RESTAURANT DEPOT SITE PLAN & CONDITIONAL USE PERMIT

SP# 01-26 & CUP# 01-26

STAFF REPORT

June 24, 2026

Figure No.1 additional Driveway Realignment Crowley review comments

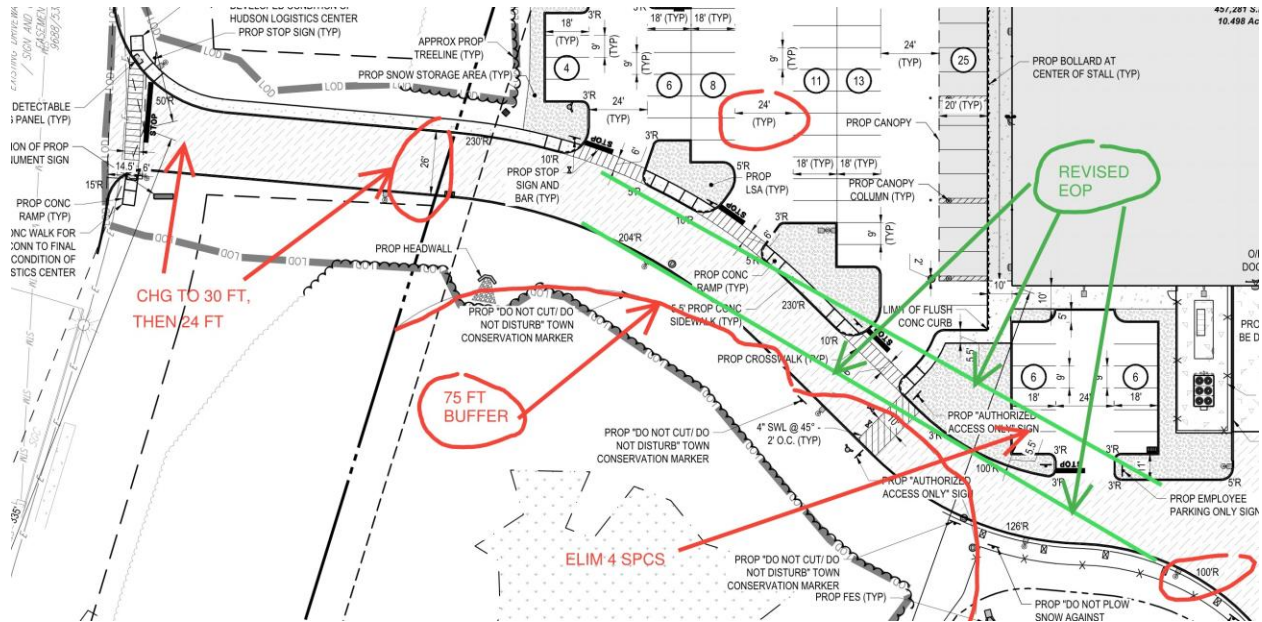
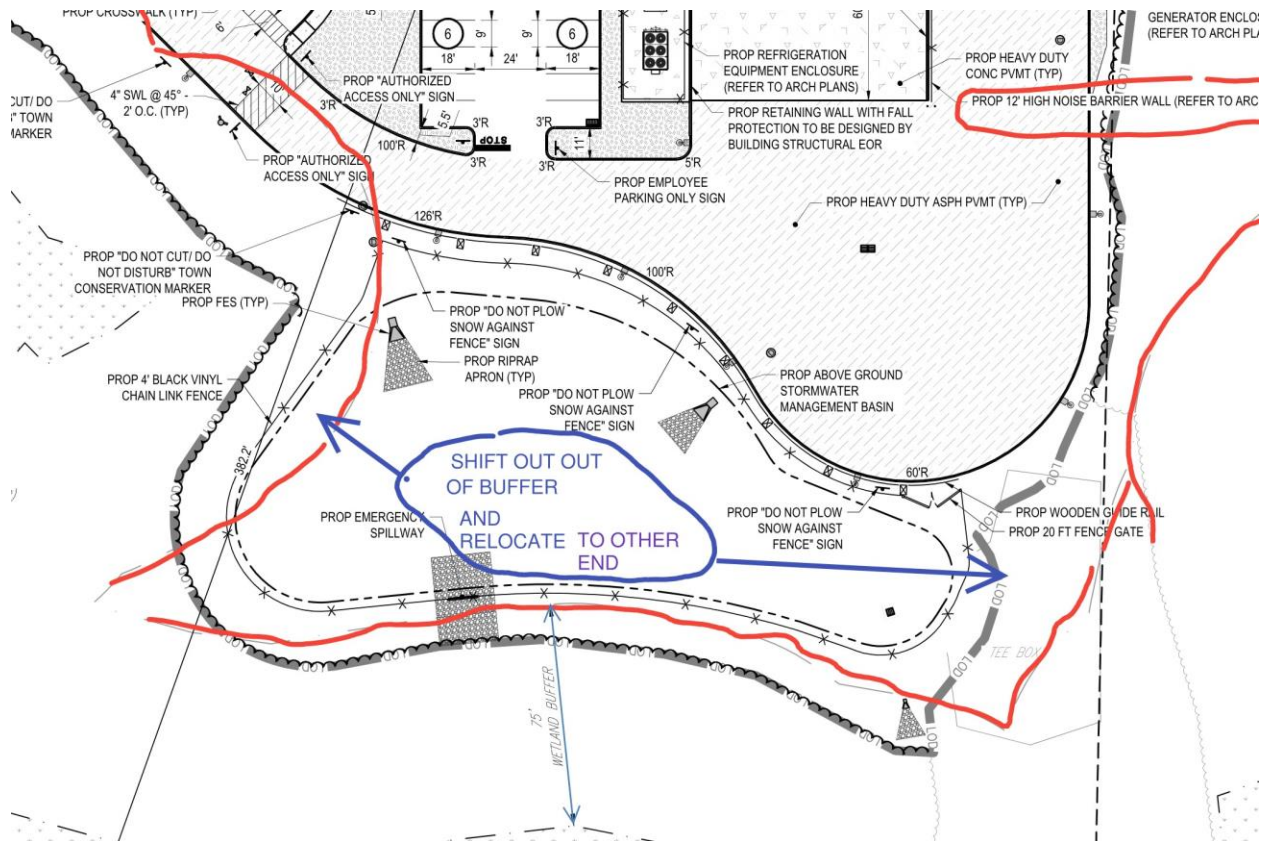
4. **OBSERVATION:** I note the Town engineer wants the driveway entrance connection to Green Meadow Drive to be 30 feet and side slopes of the facility driveway to be 3:1. **QUESTION:** Will the applicant agree to change Driveway entrance to 30 feet width and taper driveway back to 24-foot width within a practical distance.

5. **OBSERVATION:** Refer to the following Figure No.1 on additional Driveway Realignment Crowley review comments:

- Red outlines are 75-foot Wetlands Buffer
- Green lines are 24-foot driveway alignment to keep pavement out of buffer area
